ACCESS REPORT

**ISSUED FOR STATE SIGNIFICANT DEVELOPMENT
APPLICATION**

Block 20A Edmondson Park

250607-Access-r3
15/04/2026

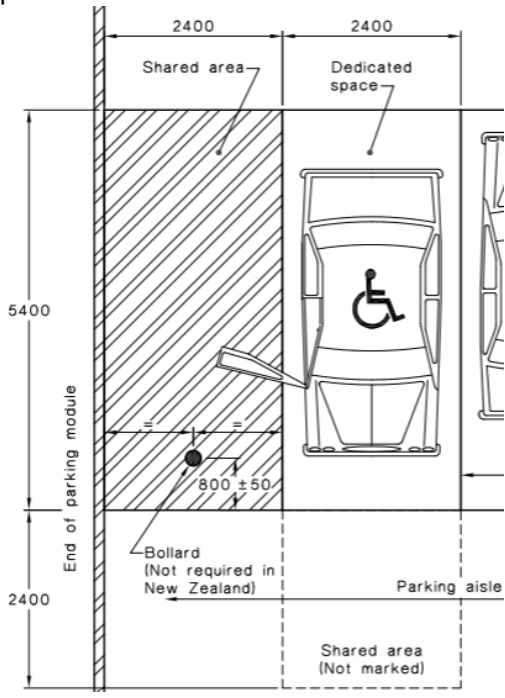
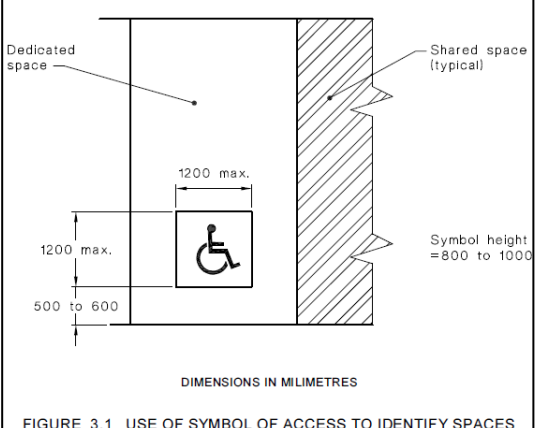
Item	Possible Performance Solution	DtS Provision	Performance Requirements
1.	Accessible carparking spaces shared zone The accessible carparking shared zone currently contain structural columns in lieu of bollards in accordance with AS2890.6. A performance solution may be sought to address this issue depending on the final location of the structural columns within the shared zone.	D4D6	D1P8

Item	Design Consideration	DtS Provision
1.	Accessible Carparking spaces The clear ceiling height in the accessible carparking space is required to be a minimum of 2,500mm.	D4D6

2.	Accessible Carparking spaces The retail and carshare spaces have not been provided with an accessible space each.	D4D6
3.	Livable Housing Please see livable housing assessment in Part 5 of this report below. Items 4 and 6 require attention.	-

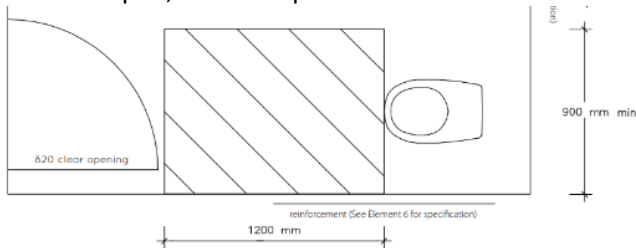
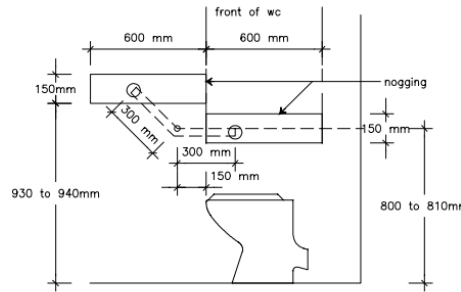
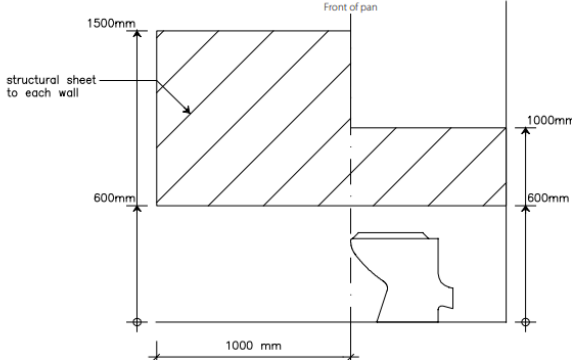
Part	Comments	Assessment	
	(ii) have a minimum 1,200mm clear circulation space forward of the toilet pan, exclusive of the swing of the door; and The 900mmx 1200mm clear zone should be shown in front of the pan, see example below:  See below showing grabrail requirements, a few toilets do not provide the required wall length for a grabrail installation e.g. Unit 1.03 Silver level requirements apply.  Figure 6(a) Toilet – Location of reinforcement  Figure 6(b) Toilet – Location of sheeting (iii) be located in the corner of the room if it is located in a combined toilet/bathroom.	Complies	
5	Shower	One (1) bathroom is to feature a slip-resistant, hobless shower recess located in the corner of the room. Shower screens are permitted provided they can be easily removed at a later date.	CRA
6	Reinforcement of bathroom and toilet walls.	Except for walls constructed of solid masonry or concrete, the walls around the shower, bath (if provided), and toilet must be reinforced to provide a fixing surface for the safe installation of grabrails in accordance with the requirements of this clause. Updated plans are required to show the reinforcement.	FI
